DATE: FEBRUARY 12, 2013 SERVICE BULLETIN #20121106 - REV 1

SUBJECT: "Reserve Staging Loop" with support washer. We (manufacturer) require the washer be removed. At the next scheduled repack cycle, remove the washer from the bungee staging loop and tie a double over-hand knot as instructed below and reinstall.

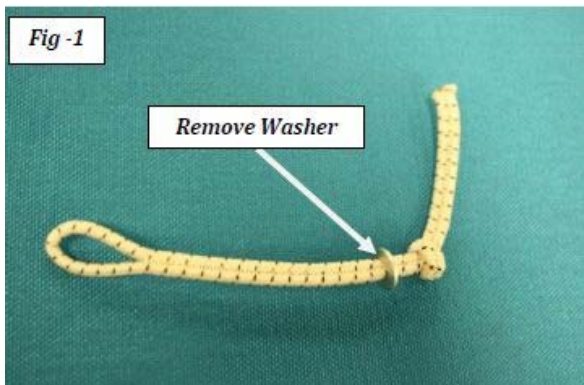
SERVICE BULLETIN: At the next scheduled inspection/repack cycle remove the support washer from the "Reserve Staging Loop." (Fig-1) Inspect the internal and external condition of the staging loop and replace it if any damage is found. Tie a "Double Over-Hand Knot" at the prescribed location. The staging loop length should be 1-inch (25mm) shorter than the reserve closing loop. Mark the loop at the desired length. Fig-2 shows a single over-hand knot. Fig-3 shows the loop end passing one more time through to create the double
